SUMMARY OF CHANGES TO
NEUTRONICS DESIGN METHODS AND VERIFICATION
OPPD-NA-8302-NP
Rev. 04

Omaha Public Power District
Nuclear Analysis
Reload Core Analysis Methodology

NEUTRONICS DESIGN METHODS AND VERIFICATION

OPPD-NA-8302-NP
Rev. 04

FIGURE 2-1

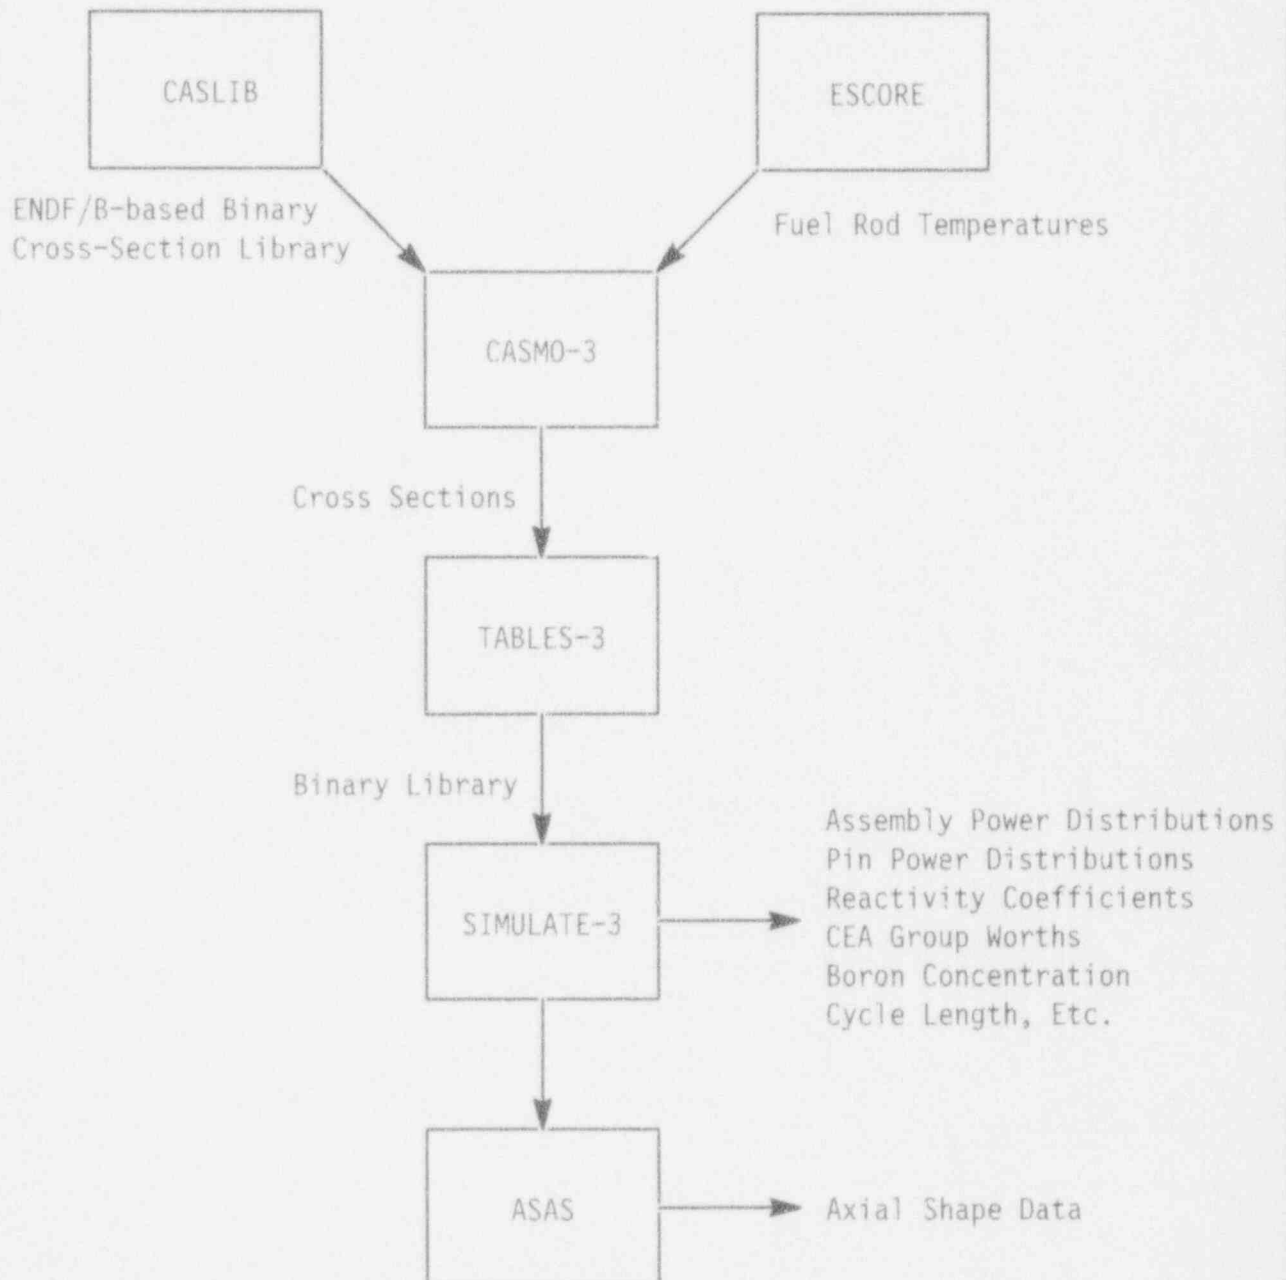
- Figure for new code(s) sequencing and flow chart.
9. Pages 12-18 Revisions to Application of Physics Methods:
 - Replace "ROCS" or "MC" with "SIMULATE-3" where appropriate.
